### **Responses to Comments and Compilation of Comments Received for the Lost Creek Uranium *In-Situ* Recovery Project DEIS**

**PUBLIC COMMENTS AND BLM RESPONSES  
ON THE  
DRAFT ENVIRONMENTAL IMPACT STATEMENT  
FOR THE  
LOST CREEK ISR PROJECT, SWEETWATER COUNTY, WYOMING**

**FIGURE 2.2-3**  
**Alternate Access Road Map**

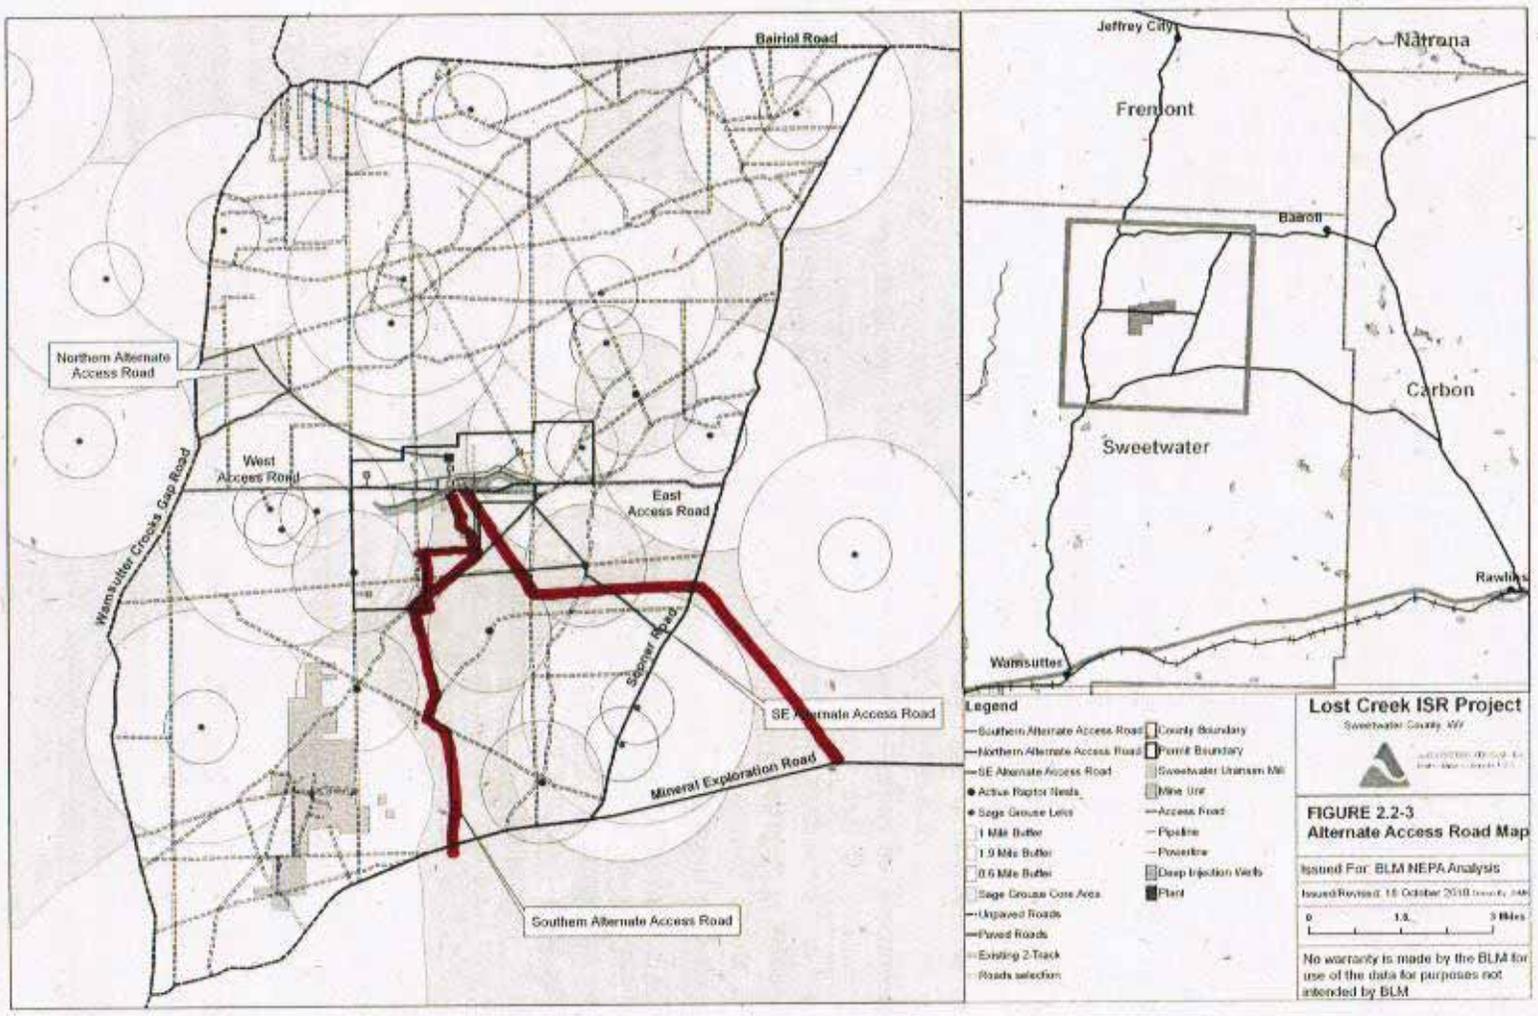
The Southern Alternate Access Road avoids lands within 1.9 miles of sage grouse leks as well as lands within 1 mile of active raptor nests. See Figure 2.2-3. DEIS at 2-93. We would recommend straightening this route while still avoiding the 19.-mile lek buffers and 1-mile raptor nest buffers. It would also be possible to establish a new access route, beginning just east of the Southern Alternate Access Road and traveling southeast for approximately  $\frac{3}{4}$  mile before swinging due east to intersect the Sooner Road and then continuing southeast to avoid 1.9-mile lek buffers to reach Mineral Exploration Road. See Figure 2.2-3 and Attachment 1. For the purposes of these comments, we will call this the Eastern Alternate Access Road. It has not to date been considered by the BLM according to the DEIS.

Similar to the concerns noted for other alternate road locations analyzed in Section 2.3.3.8, the alternate road locations suggested by BCA, violates the EO by disturbing and fragmenting a significant amount of habitat, despite being outside the 1.9-mile buffer. Also, the BCA SE Alternate Access Road, which follows a somewhat different route than the SE Alternate Access Road shown on Figure 2.2-3, still crosses the 1-mile buffer around two raptor nests.
